ISSUE: Permit to Demolish/Capsulate (partial), Certificate of Appropriateness for alterations and Waiver of Rooftop HVAC Screening Requirement

APPLICANT: Anne Toth

LOCATION: Old and Historic Alexandria District
413 North Washington Street

**BAR #2021-00236 & BAR #2021-00261**
413 North Washington Street

1 Rear (East) Elevation
Scale: 1/8" = 1'-0"

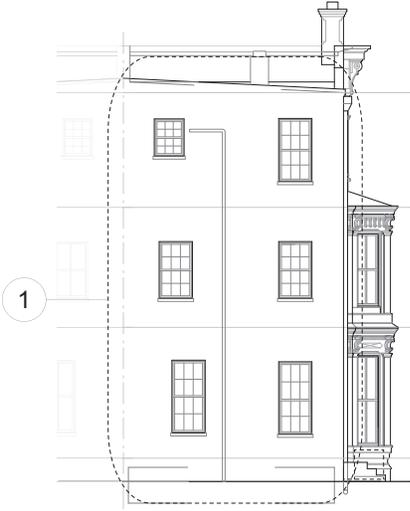
While staff does not typically support the wholesale demolition and reconstruction of historic walls, the accompanying structural report identifies significant problems and past repairs that have made this wall structurally unsound. Therefore, staff supports the demolition of the rear wall, particularly because historic brick will be salvaged and used in the reconstruction of the wall. Staff also supports the minor demotion on the top floor of the north elevation to add a single window, and the removal of a portion of the flat roof to create the sunken roof deck. While significant, the removal of the roof does not change the appearance of the building and it could easily be replaced in the future. The masonry material that will be demolished for the project is limited to secondary elevations with limited visibility from the right-of-way and is not of unusual or uncommon design and the affected portions it could be reproduced easily today. In the opinion of staff, none of the criteria for demolition and capsulation are met and the Permit to Demolish/Capsulate should be granted.

Staff supports the proposed modern fenestration changes on the rebuilt rear elevation. This elevation will only be visible, and minimally so, from oblique views from Princess, Oronoco and St. Asaph Street. While the rear wall will contain some historic brick, it is essentially a blank canvas and the use of modern fenestration helps to differentiate this part of the house from the largely untouched side and front elevations. While this elevation is not an addition, it is consistent with the *Design Guidelines* recommendation that “An addition to a historic building should be clearly distinguishable from the original structure. An addition should not obscure or dilute the architectural and historic importance of an existing building by creating a false sense of the past.”

Figure 1: East Elevation with Structural Conditions Noted

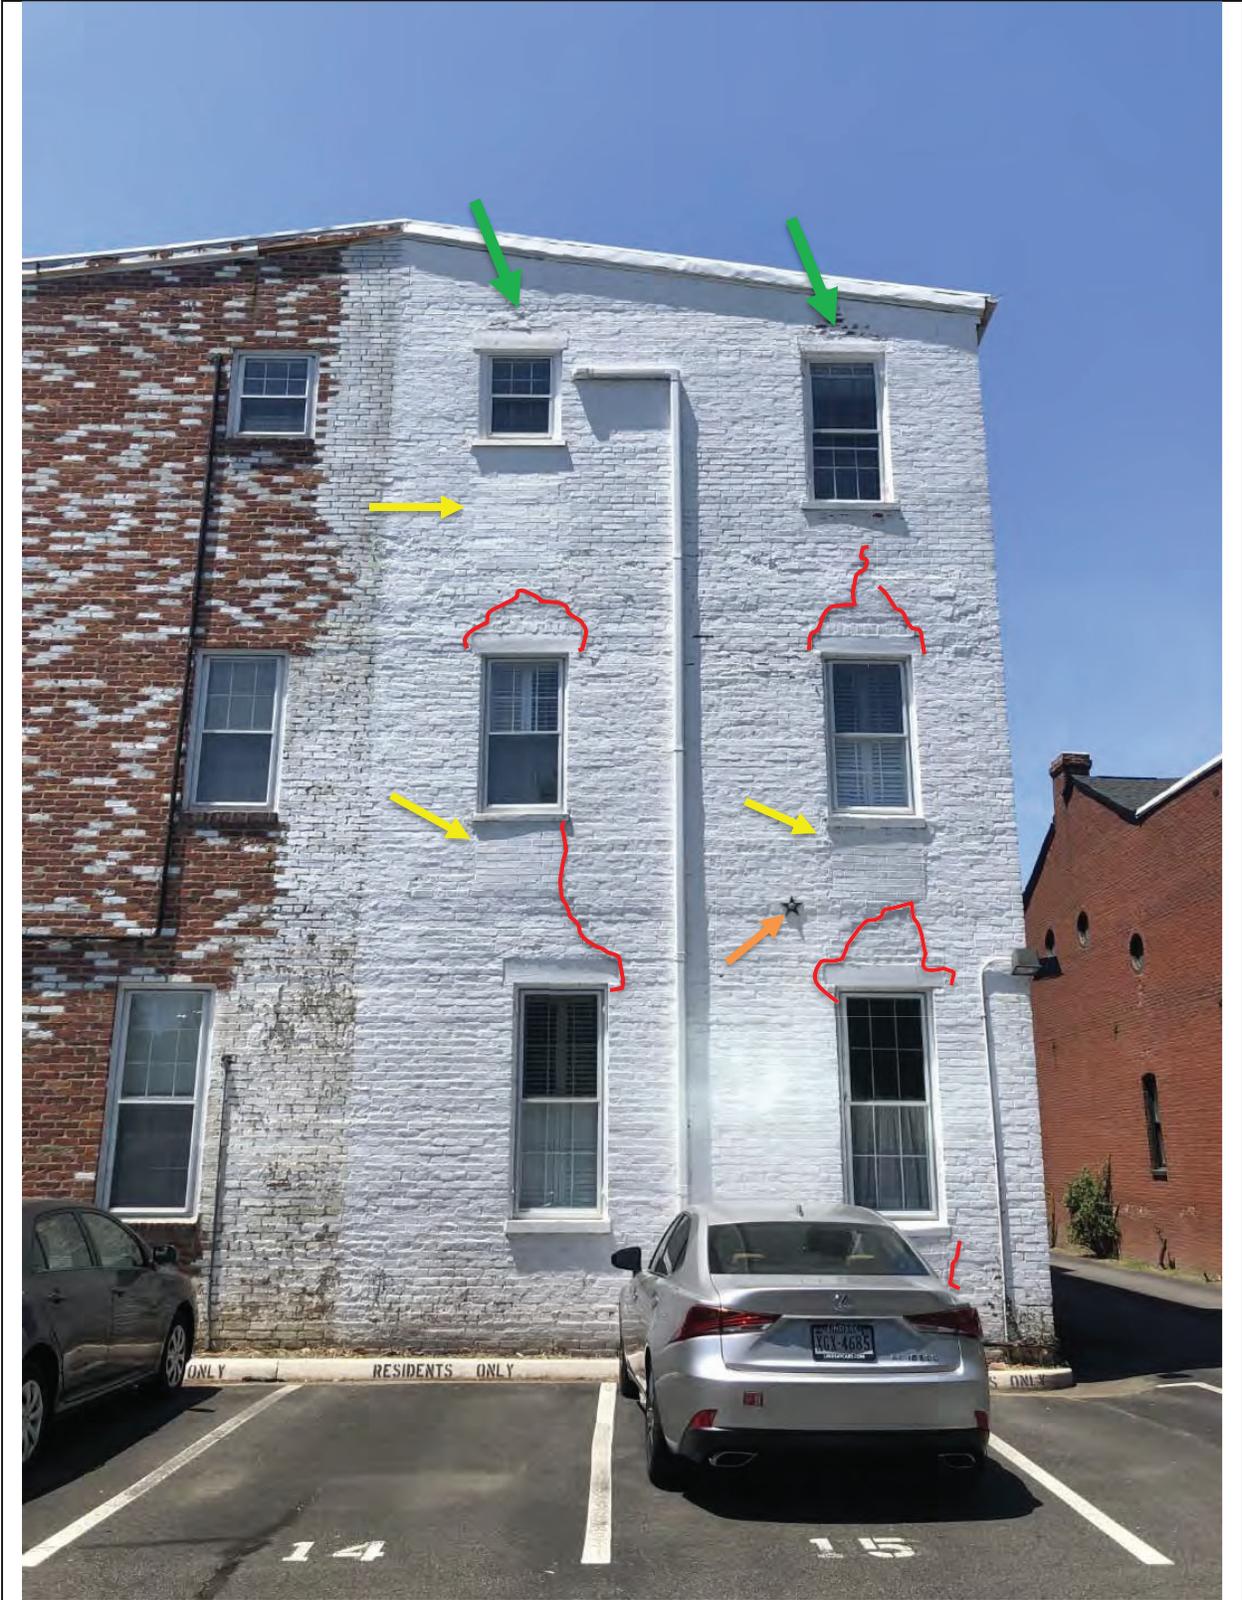
Figure 1 shows the conditions of the east wall in broad perspective.

The red lines represent larger scale cracking that is generally focused around the window openings (shown in some detail in Photo 3). The cracking is likely the result of several factors, the first of which is the apparent replacement of the wood lintels at some point in the past. The current lintels, with smooth finish and sharp 90 degree edges, are clearly newer and sawn from modern machinery. The original wood likely rotted from the sustained presence of moisture in the wall. As the rear wall functions as a primary component of lateral resistance for the building, the cracking may also be associated with stresses imposed on the façade from wind and seismic loadings (recalling the 2011 Mineral, VA earthquake as a fairly recent, significant event). The loose connection of the east façade to the floor and roof diaphragms and its resulting bowing, as discussed below, is also likely a factor contributing to the masonry cracking. An important note is that the cracking observed is clearly subsequent to the latest painting effort, and also after the lintel replacement.

The green arrows show examples of paint loss that is the result of brick deterioration. The loss of coating is fairly widespread, with concentrations above the upper two windows (Photo 4). However, the coating loss is less important structurally than the material disintegration of the brick units and mortar that appears to be the root cause within the wall construction. This is likely the result of sustained moisture within the wall, perhaps even being retained by the coating, and then the resulting stressing from freeze-thaw cycling. As retained water freezes it expands volumetrically, inducing internal stresses to the moisture-containing masonry.

The yellow arrows show areas of infill below windows. It appears that there was some sort of accessible porch as the windows were previously serving as doorways. The new brick has not been toothed into the original jambs, providing a

The orange arrow shows a single star anchor located at the 2nd floor level. Star anchors are a traditional way of bracing the exterior masonry façade to the floor and roof diaphragms, particularly along facades where the interior framing does not bear on the exterior wall, and instead runs parallel to the wall. The wood joists and rafters of the interior floor and roof framing run north-south here and, as such, provide limited bracing to the east wall. The single star anchors appears to have been installed in response to outward bowing of the wall, however would not fully address the bowing as currently observed.

Using a 4 foot level and tape measure, Matteo measured the wall at the first floor level to be out of plumb on the order 1 inch over the 4 foot length. As such, the wall is estimated to be bowing on the order of 3 inches at around the mid-height of the second floor. This bowing imposes bending stresses in the wall as the result of an eccentricity between the weight of the wall above and its misaligned position below, rendering the wall more susceptible to failure when subjected to larger loadings.

The structural conditions noted above warrant significant structural repair and stabilization as part of the upcoming renovation and preservation work. Of particular concern is the outward bowing of the façade, which needs to be minimally addressed with more robust connection to the floor and roof diaphragms. Also very significant, but less easily quantified, is the apparent deterioration of the mortar and masonry units that has resulted from a long history of moisture infiltration and entrapment. The combined effects of these structural conditions and the history of modification (window infills, lintel replacements) makes a more substantial rebuilding much more appropriate and offers an opportunity to restore physical integrity to this essential component to the building structure.
